DESIGN ADVISORY BOARD Tuesday January 12, 2016 at 3:00 PM Conference Room 12, City Hall, Burlington, VT Agenda

1. **16-0724PD; 451 Ethan Allen Parkway (RL, Ward 7N) Ellis/Alles**
Preliminary plat proposal for 9-unit planned unit development in three buildings and associated site improvements.

Request: Preliminary plat review for 9-unit planned unit development and associated site improvements

RE: ZP16-0746SP, Sketch Plan Review for 66, 72, 80, 94 and 96 Colchester Avenue; 27 and 49 Fletcher Place

**EXISTING CONDITIONS
SITE PLAN**

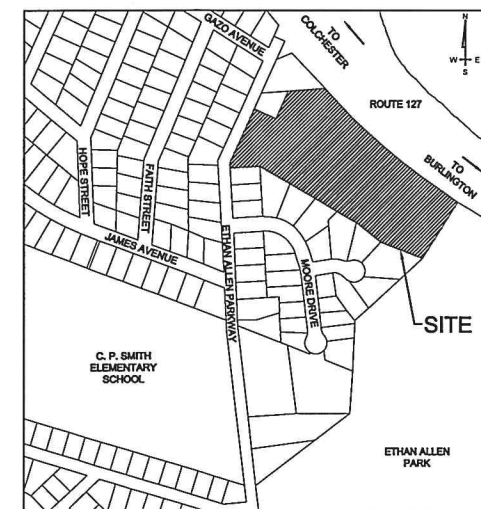
Important natural features consist of several large trees and extensive wetlands. Sheet 2, Existing Conditions Site Plan, depicts specimen trees (>30" caliper or 100+ years old) and the wooded area generally. Clearing limits are depicted on sheet 4, Site and Utility Plan.

LANDSCAPING & GRADING PLAN

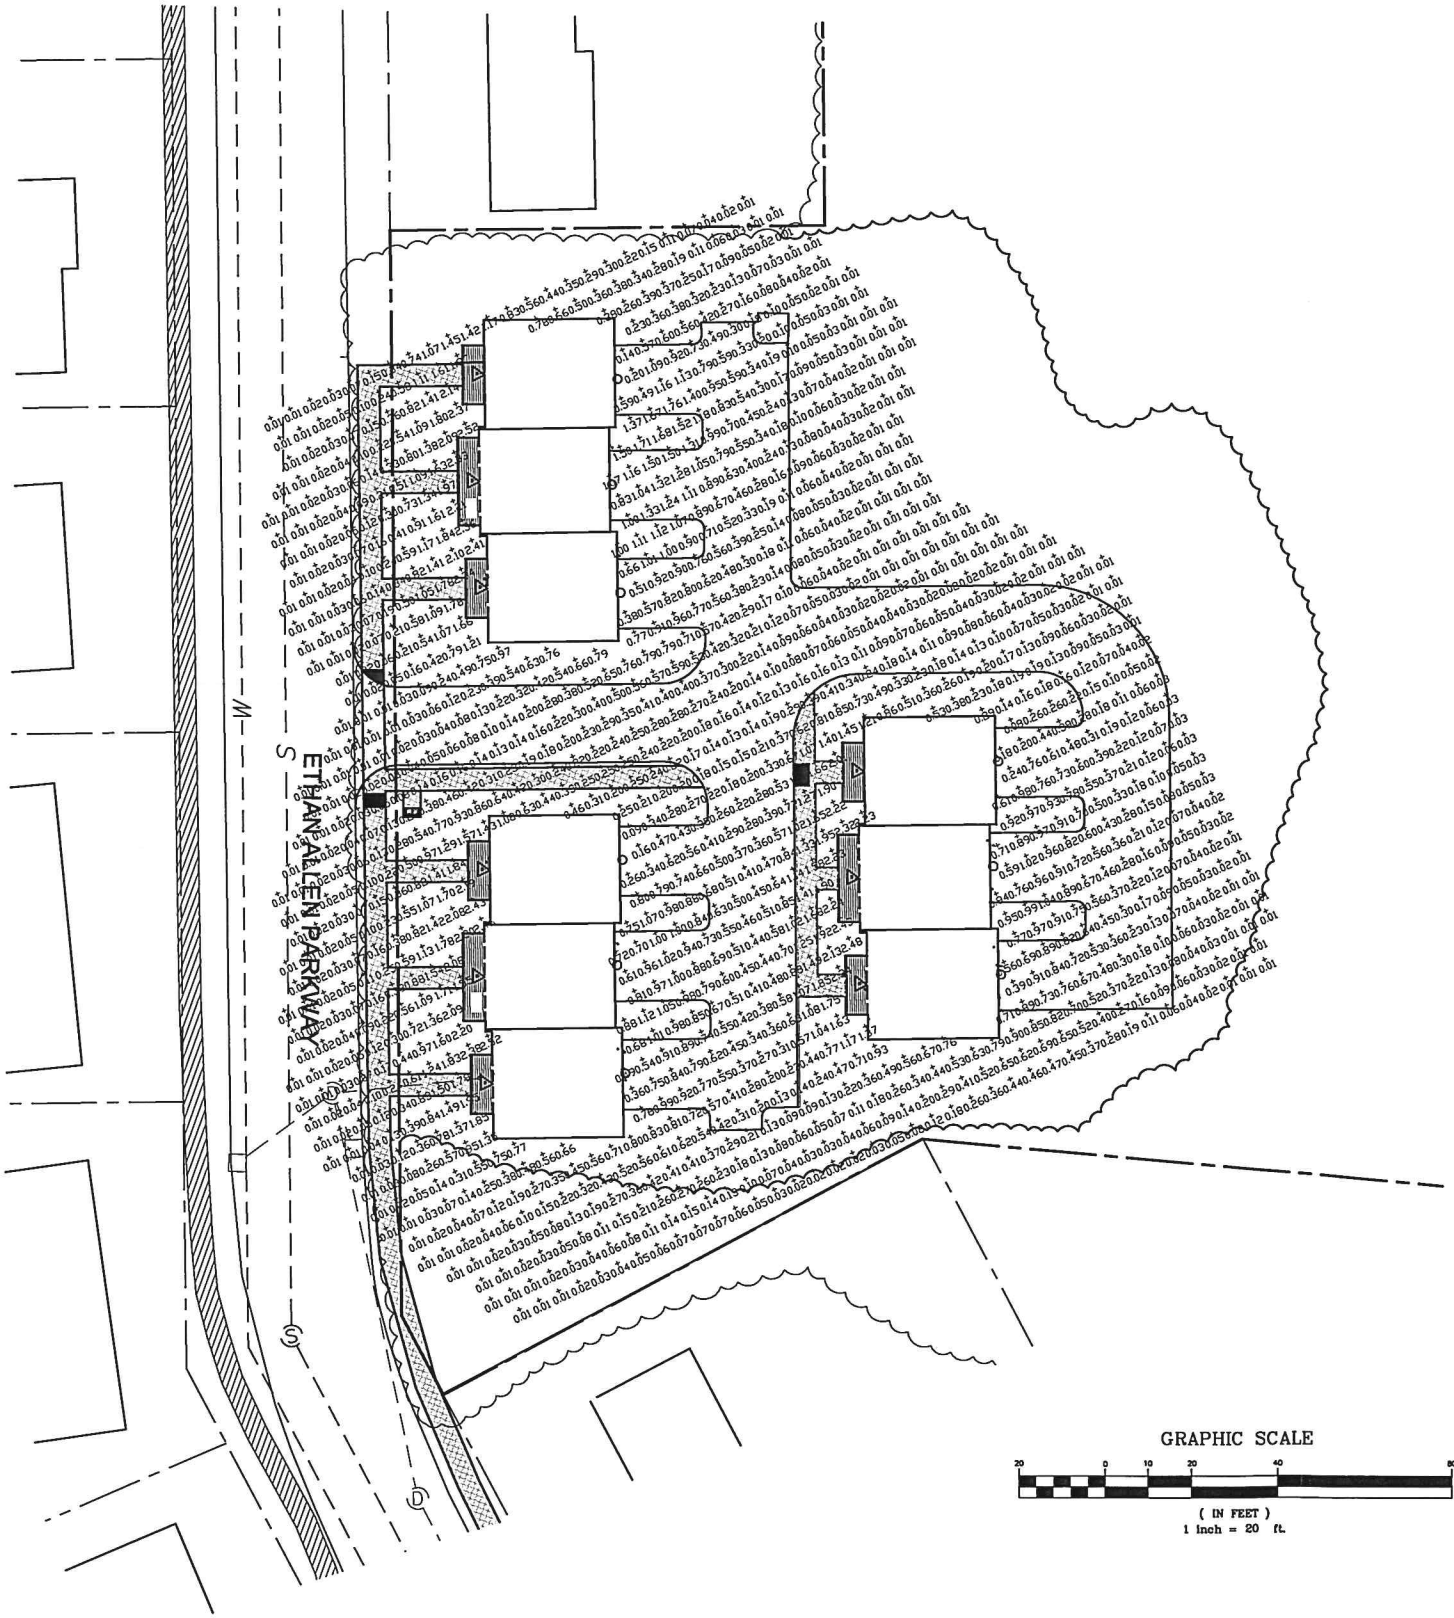
A landscaping plan has been provided and consists of fairly typical residential plantings. A variety of trees and shrubs are proposed and are used as foundation and accent plantings. Relatively dense plantings are proposed at either side of the development to provide screening for neighboring properties to the north and south. No new fencing is evident.

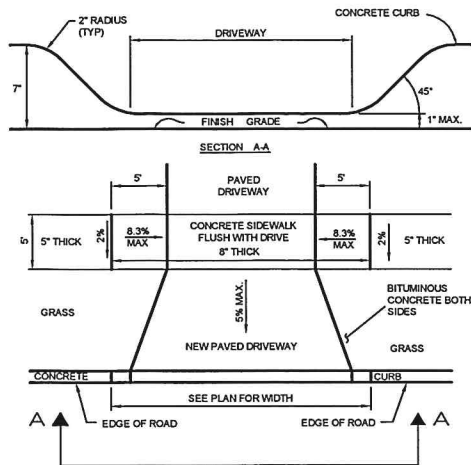
Exterior lighting is limited to front entries and garage doors. A photometric plan has been submitted and depicts acceptable lighting levels (average of 0.57 footcandle). The photometric

plan incorporates two fixture types – for front entries and for garage doors. The single fixture cutsheet provided matches neither. Cutsheets for the fixtures in the photometric plan must be provided.

1. Analysis of buildable area by a third party is recommended.
2. Address handicap accessibility.
3. Provide fixture cutsheets for the lighting fixtures in the photometric plan.
4. Provide detail drawing of dumpster enclosure.
5. Provide railing details.
6. Depict utility meter screening.
